Vermont Agency of Transportation  
**RECEIVED**  
 ON: **January 29, 2014**  
 and Checked for  
**CONFORMANCE**  
 BY: **Rob Young** DATE: **02/18/2014**

0						
REV.	DATE	REMARKS	DWN	CHK	APVL	SHOP
MATERIAL:		SURFACE PREP. & PAINT:		HOLES:		SHOP BOLTS:
DESCRIPTION: GENERAL NOTES						
CASCO BAY STEEL STRUCTURES, INC. 1 WALLACE AVE. PHONE (207) 780-6722 SOUTH PORTLAND, ME 04106 FAX. (207) 780-6726						
STRUCTURE: VT ROUTE 100 (MINOR ARTERIAL) OVER MAD RIVER BRIDGE NO. 166 WARREN COUNTY OF WASHINGTON			DRAWN: CRK	DATE: 01/07		
			CHKD: DO	DATE: 01/08		
LOCATION: TOWN OF WARREN			JOB NO.	DWG NO.		
PROJ NO. BRF 013-4(32)			<b>548</b>		<b>GN1</b>	
CUSTOMER: VT AOT					REV.

ONE ~ GIRDER ~ IG1

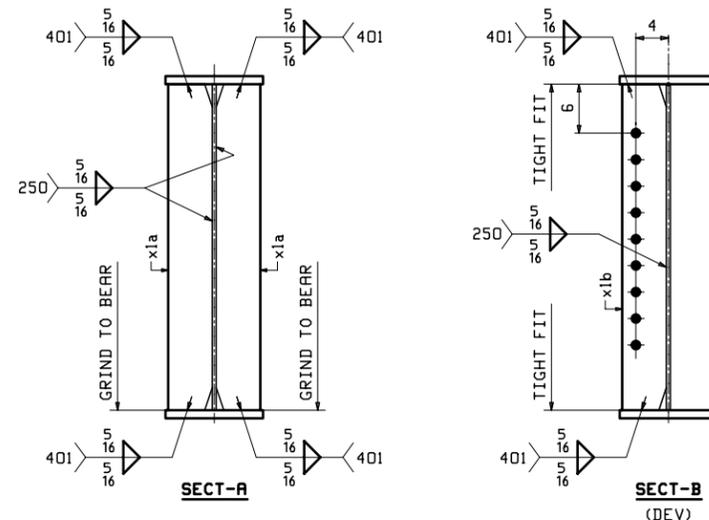
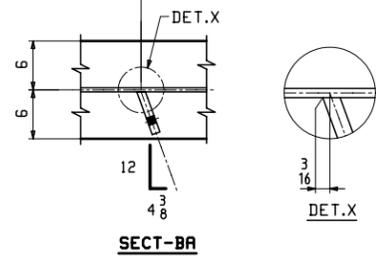
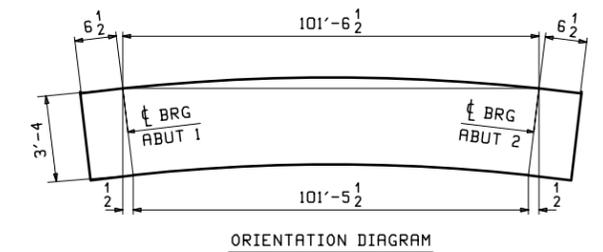
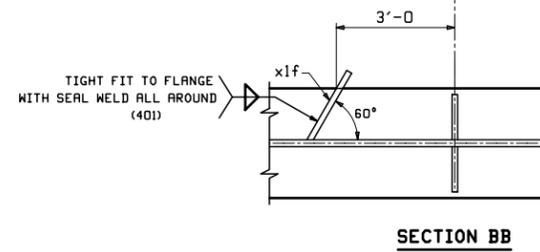
6" Stud Height Acceptable
